December 6, 2024

IDEA Exterior Fencing Improvements at IDEA Donna and IDEA San Benito
CSP#19-FNCTX-1224

GMS ARCHITECTS
BROWNSVILLE, TEXAS 78526
(956) 546-0110

ADDENDUM NO. 2

A1.01

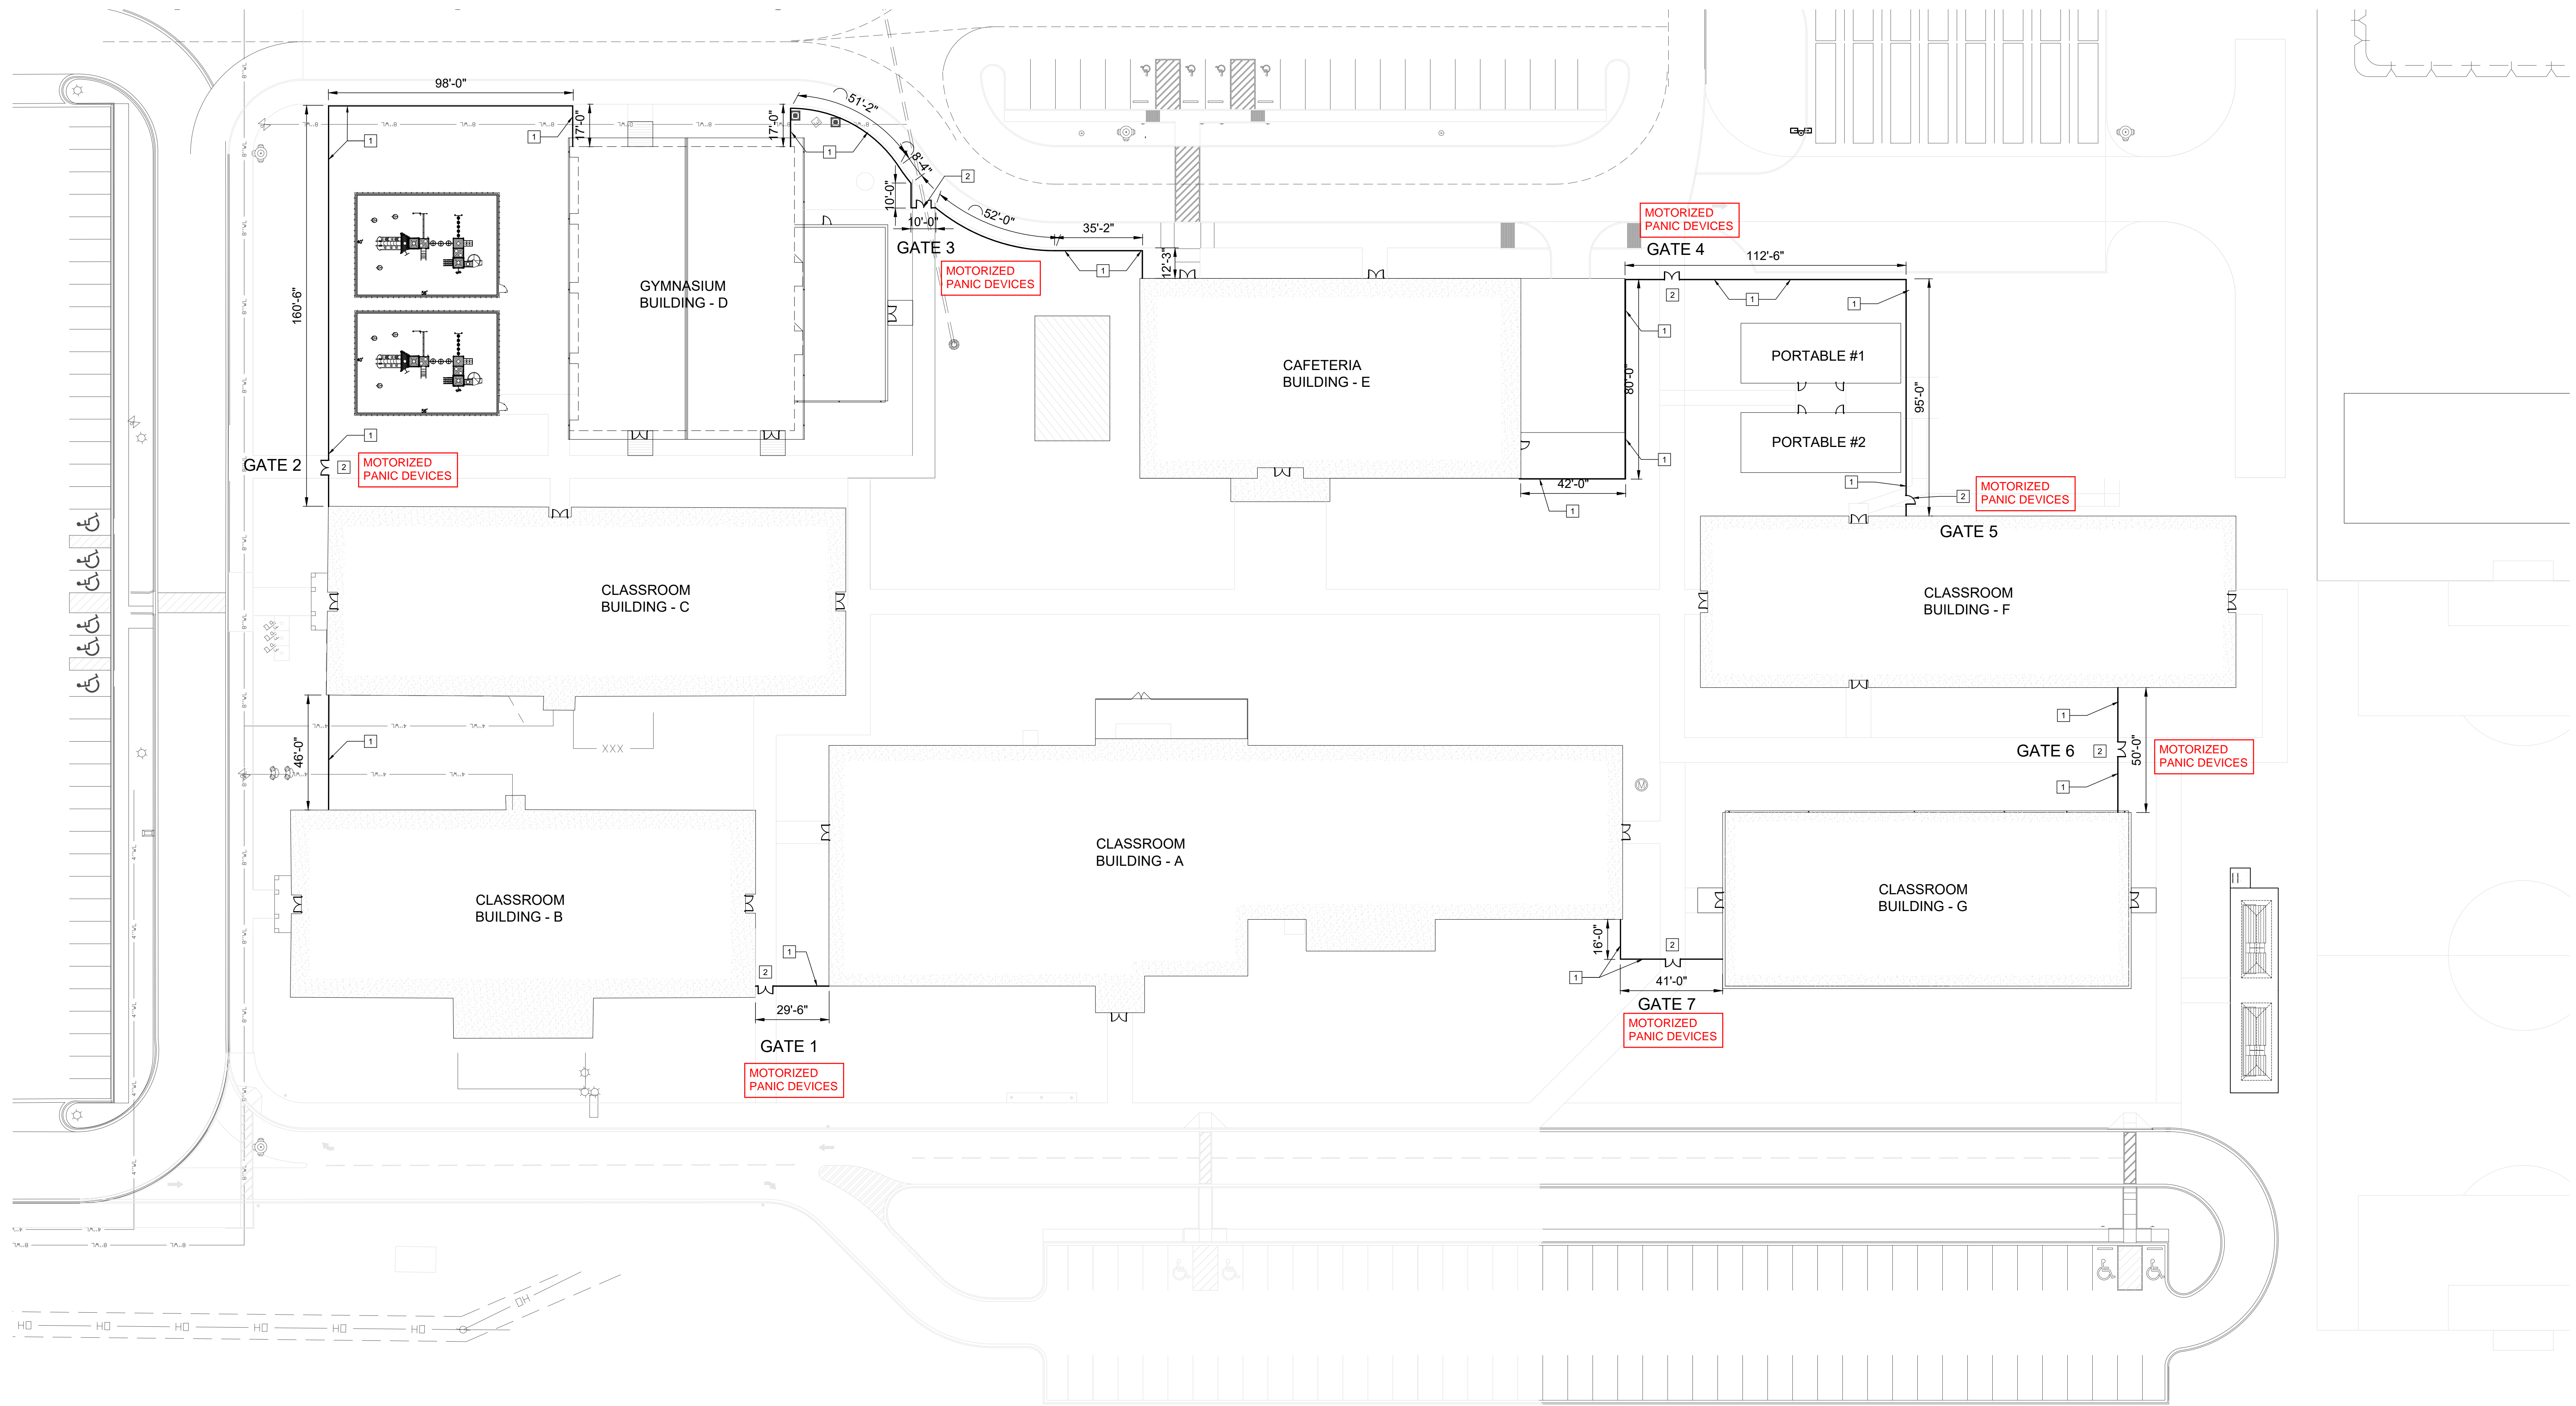
- Delete Sheets A1.01 and SB1.01 and replace with attached Sheets A1.01 and SB1.01.

- 1 6'-0" HIGH SECURITY CHAIN LINK FENCING AS SPECIFIED. REFER TO A1.03
- 2 PAIR OF 3'-0" WIDE 7'-0" HIGH SECURITY ENTRY SWING GATES WITH MULLION, HYDRAULIC HINGES AND PANIC DEVICES AS SPECIFIED. REFER TO A1.03.
- 3 4'-0" WIDE 7'-0" HIGH SECURITY ENTRY SWING GATES WITH MULLION, HYDRAULIC HINGES AND PANIC DEVICES AS SPECIFIED. REFER TO A1.03.
